**CALIFORNIA REGIONAL WATER QUALITY CONTROL BOARD
LAHONTAN REGION**

SUBJECT: **WASTE DISCHARGE REQUIREMENTS, VICTOR VALLEY
WASTEWATER RECLAMATION AUTHORITY;
PERCOLATION PONDS AND BIOSOLIDS WASTE UNITS,
SAN BERNARDINO COUNTY**

**BOARD ORDER NO. R6V-2012-(PROPOSED)
WDID NO. 6B360109001**

Subject: Tentative Revised Waste Discharge Requirements (WDR) for Victor Valley Wastewater Reclamation Authority (VWVRA) Percolation Ponds and Biosolids Waste Units

FILE: Figure 1 MRP Recommended Monitoring Network 09242012.mxd Date: 9/24/2012

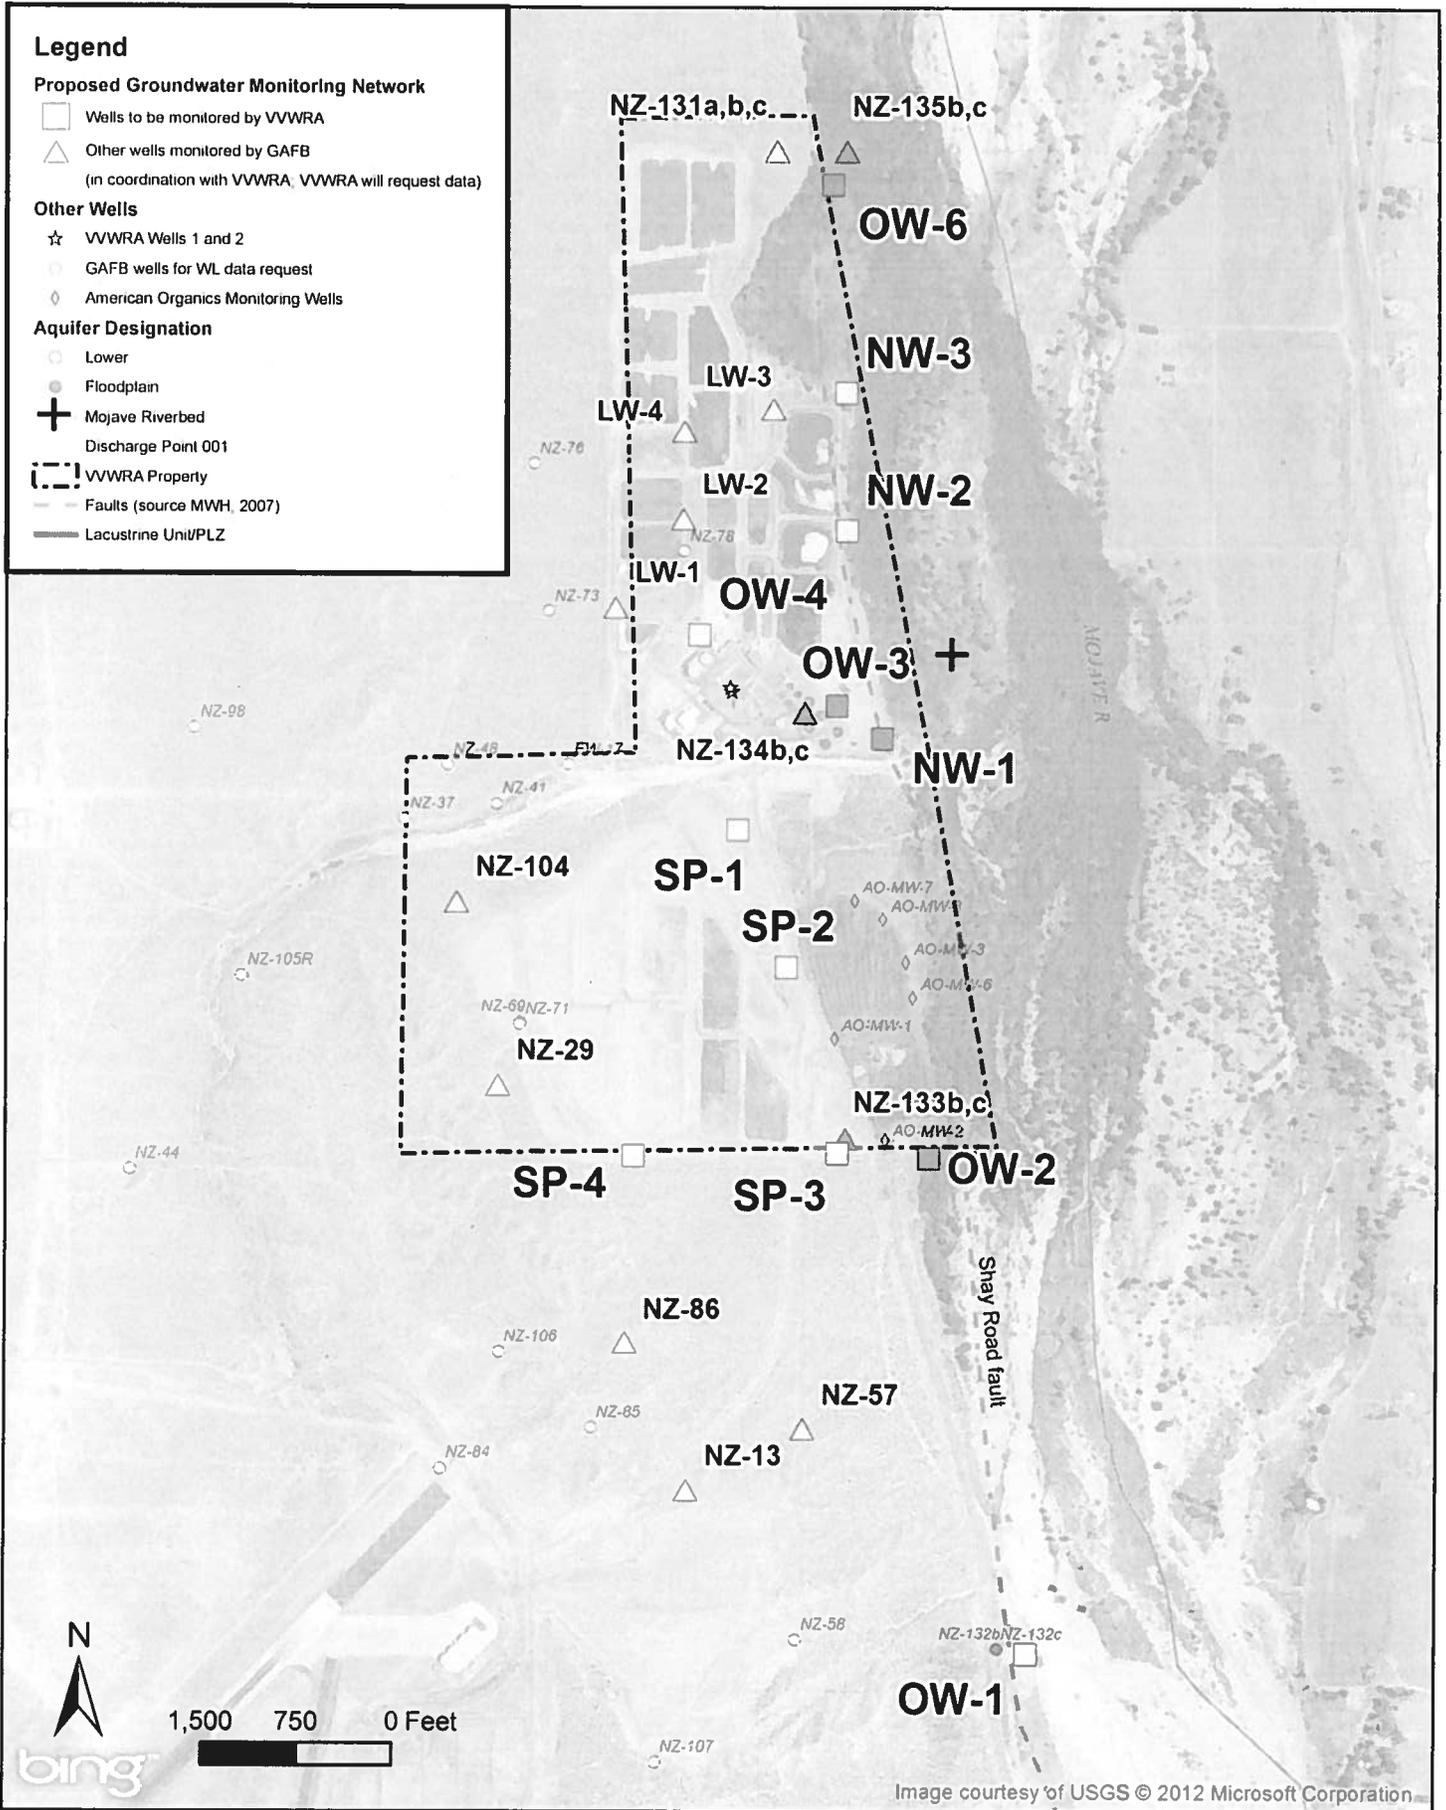
8 Finally, Regional Board staff had requested revisions to Attachment C showing the groundwater monitoring locations. This map was provided to John Morales via email on September 26, 2012. It is also at attachment to this comment letter.

ⓑ Finally, Regional Board staff had requested revisions to Attachment C showing the groundwater monitoring locations. This map was provided to John Morales via email on September 26, 2012. It is also an attachment to this comment letter.

ITEM (See Encl. 1)	RESPONSE
1	Comment Noted
2	Requested Change Made
3	Requested Change Made
4	Requested Change Made
5	Effluent limits prescribed in the Order for total nitrogen are based on calculations dependent on a 1 time per week sample frequency basis. For this reason, Water Board staff are requesting nitrogen analysis be collected weekly. To evaluate compliance with the total nitrogen effluent limit, reporting total nitrogen was added to the Monitoring and Reporting Program, Section I.D. as a calculated value. However, reporting for nitrite and ammonia is requested only twice per month.
6	Requested Change Made
7	Requested Change Made
8	Map Received
